Date: April 19, 2021

To: Andrew Sutherland, Ph.D., SJRWMD
From: HSW Consulting, LLC
Ken Water, Ph.D., PH; Dean Mades, P.E.; and Scott Emery, Ph.D.
RE: Contract 32927 / Work Order 03

Project Title: Independent Technical Peer Review
Minimum Levels Reevaluation for Sylvan Lake, Seminole County, Florida

Figure 1. Conceptual backcheck of a time-distance-drawdown relationship in a leaky artesian aquifer.

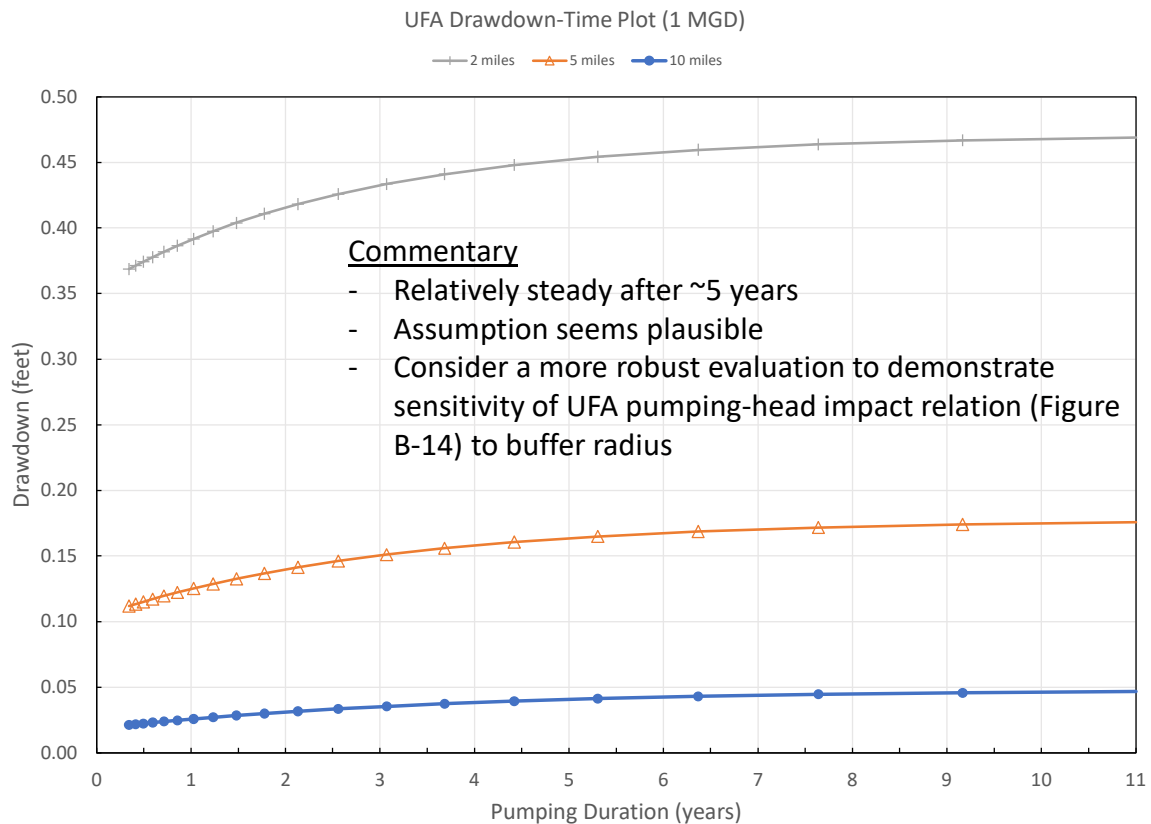
- c. A conceptual backcheck of the 10-mile buffer zone assumption (Figure 1) indicates that UFA drawdown at 10 miles associated with a well pumping 1 MGD could be measurable ($\sim 0.05'$). Consider checking the sensitivity of near-lake UFA heads to far-field pumping (outside the 10-mile buffer zone); for example, by simulating the recovery associated with holding the buffer-zone pumping at the 2003 condition and changing the 2003 far-field withdrawals to injections. An alternative approach, such as water-balance analyses, could be used. Low sensitivity would support the assumption of a 10-mile buffer zone.

Figure B-13. Estimated historical groundwater uses in Sylvan Lake basin area.

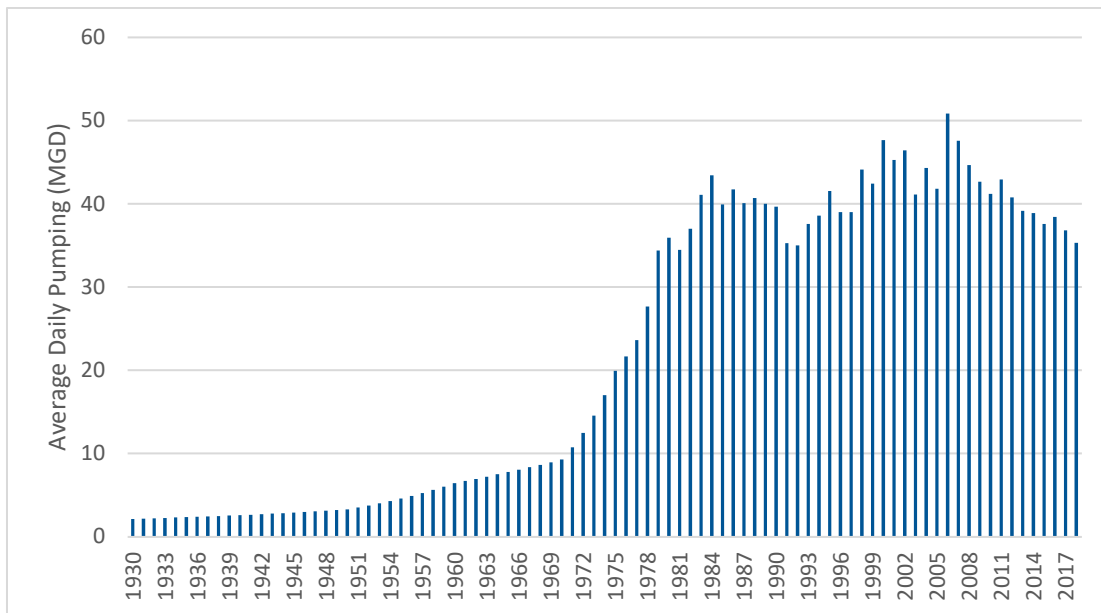
the 2003 steady-state head distribution which is associated with about 41 MGD of pumping within the 10-mile buffer and an undisclosed amount of pumping outside the 10-mile buffer zone (draft report Figure B-13). In comparison, the Calibration Period pumping within the 10-mile buffer averaged about 43 MGD.

Figures 2 and 3 depict the estimated historical regional pumping and the associated estimated lake level hydrographs based on different pumping scenarios, respectively.

Figure B-17. The estimated no-pumping and current-pumping condition levels for Sylvan Lake

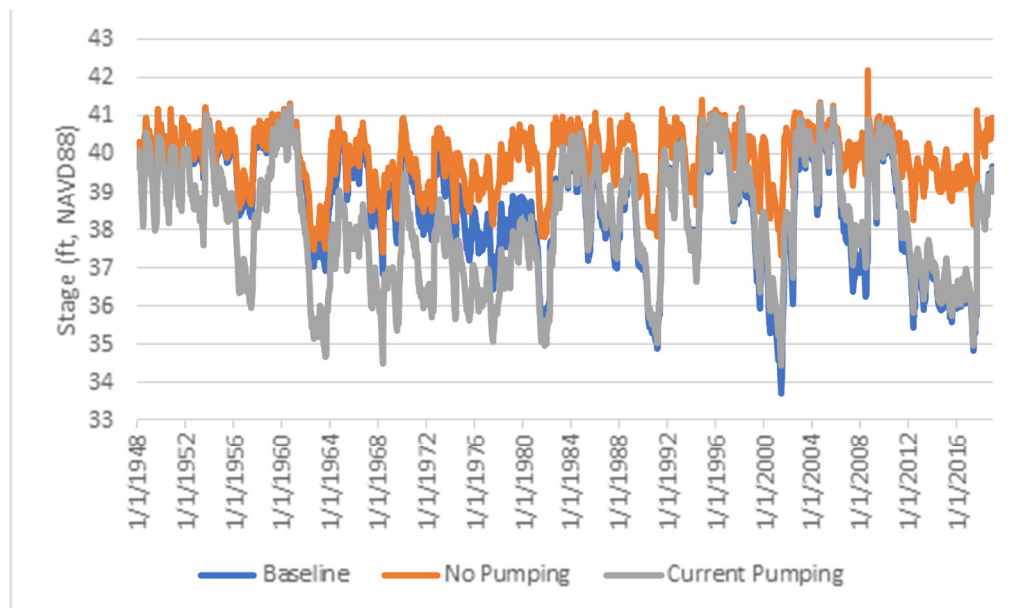
The word baseline shows up only in Appendix B, Figure B-17, and is synonymous with the historical record in this MFL. Other Districts view baseline as the historical record with the effects of withdrawals

Figure 4. No-pumping, historical (baseline), and current (MFLs) condition exceedance curves for Sylvan Lake, Seminole County, Florida

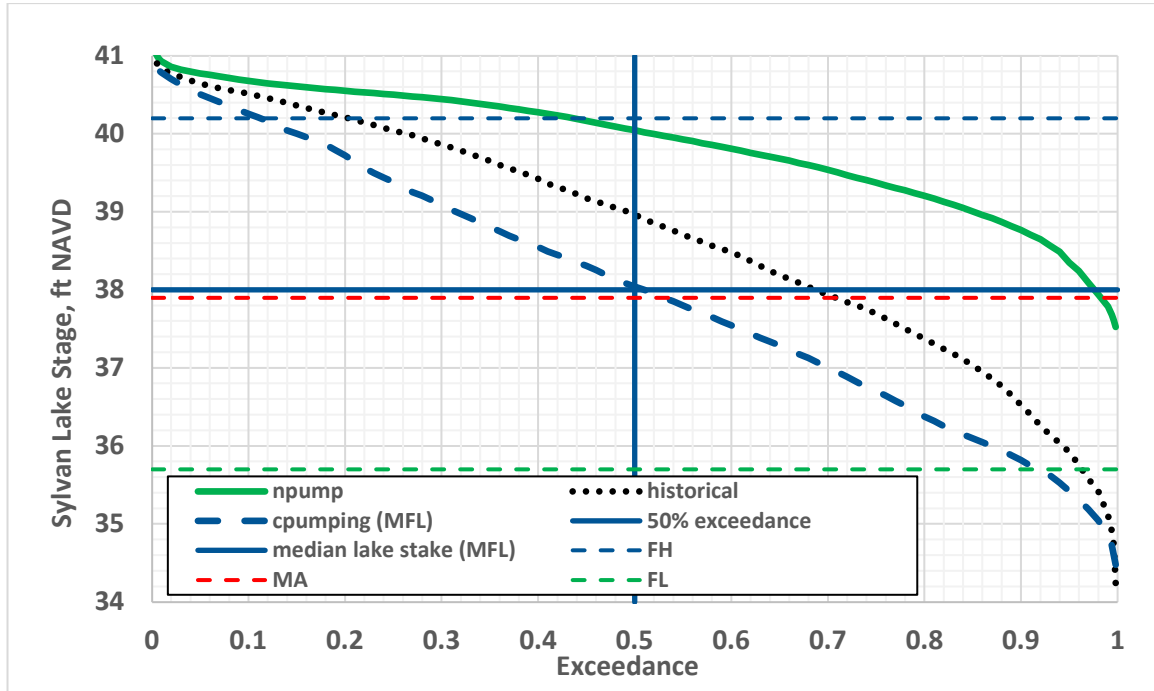
Figure 4 depicts stage duration curves for the pumping scenario data series. Note that the control structure limits the impact of withdrawals at the high stage end, and that impacts increase at progressively lower lake stage. At the median lake stage, about half of the impact occurs from the no-pumping to the historical pumping scenarios and the other half from historical to the current pumping (and the MFL) scenarios. At progressively lower lake stage, greater impact is attributed to historical withdrawals. The total estimated impact of pumping on lake level is about 2 ft at the median and 3.5 ft at minimum lake levels.

Figure 5. Minimum Frequent High (FH) Weibull plot

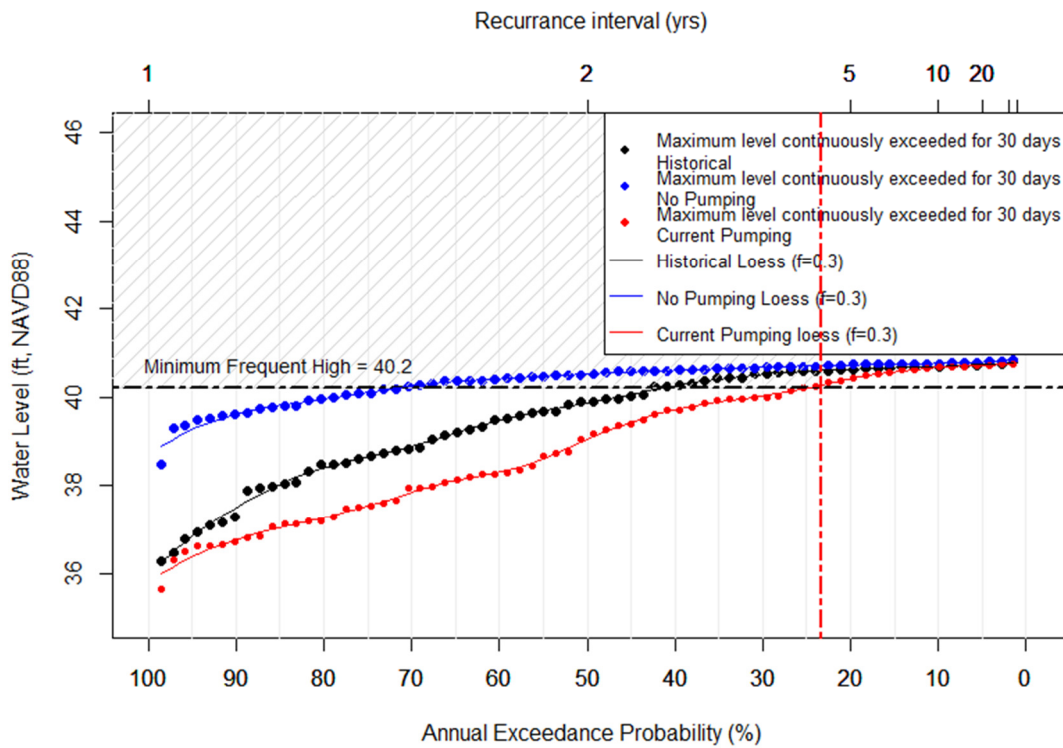
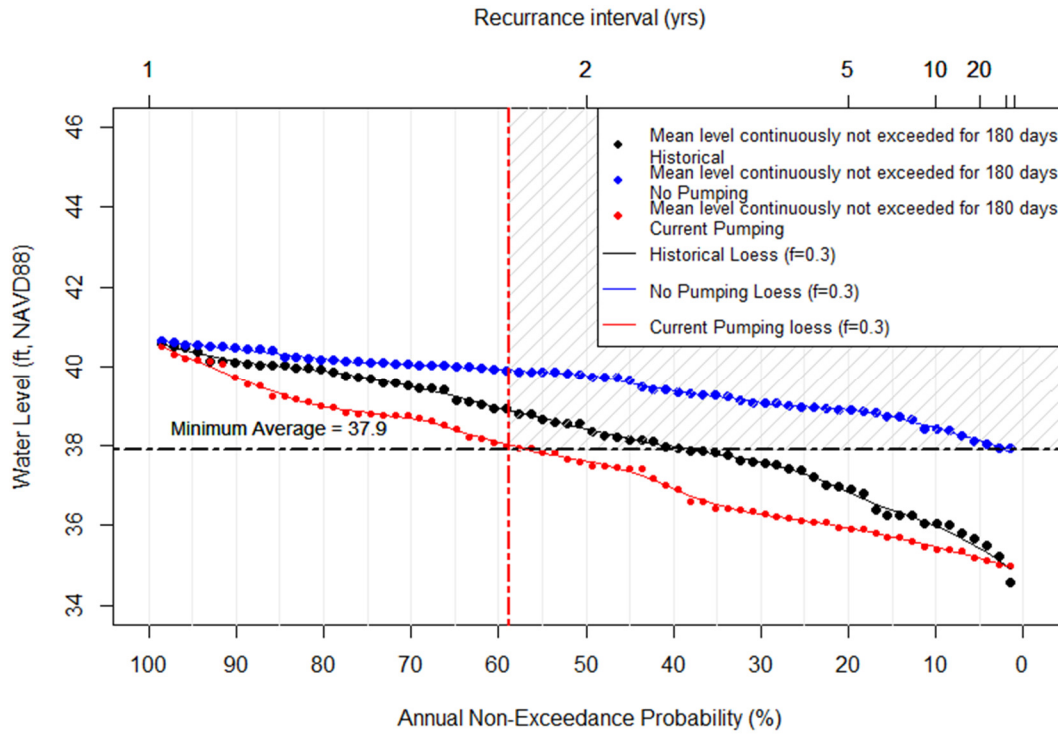
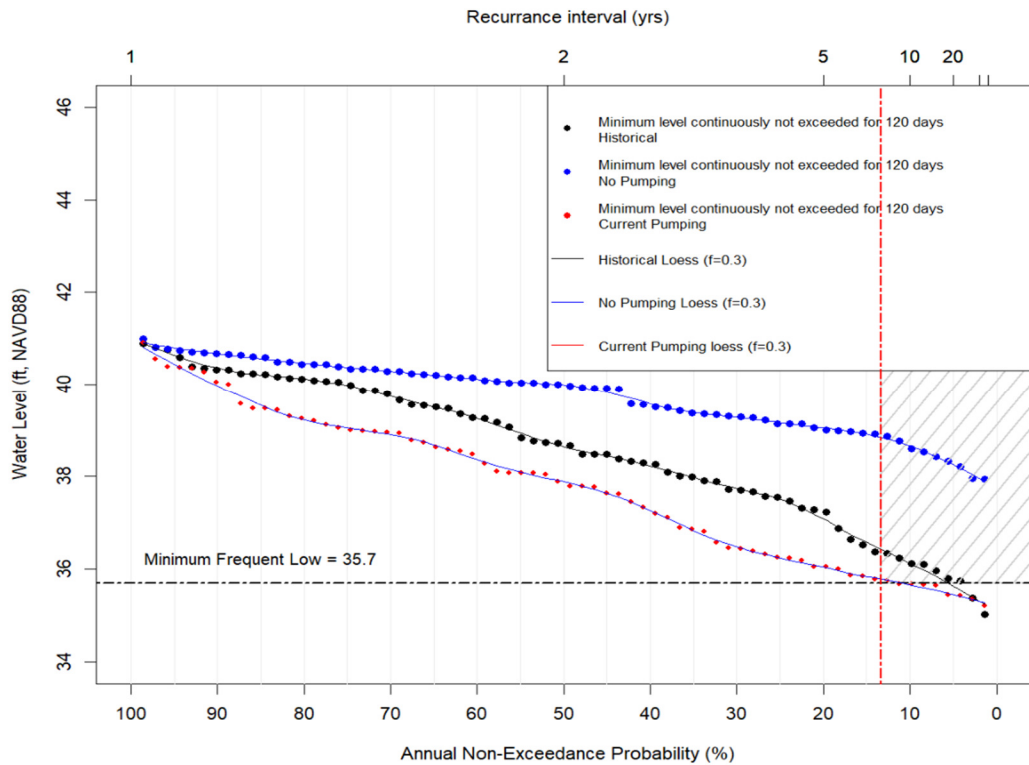
Figures 5 through 7 depict the Weibull plots associated with the three MFL metrics (FH, MA, and FL) and for the different pumping scenarios and the MFL scenario (i.e., current pumping). The Weibull plots provide information similar to the FDCs presented in Figure 4 but also support the District's approach of setting MFLs based on an allowable shift in the frequency of the key events (i.e., FH, MA, and FL).

- i. For clarity, consider adding information presented in Figures 4 – 6 to appropriate figures in the Sylvan Lake MFL Report and or appendices.
 - ii. Consider adding language that supports using the historical record as baseline, primarily as related to the position of wetland communities.
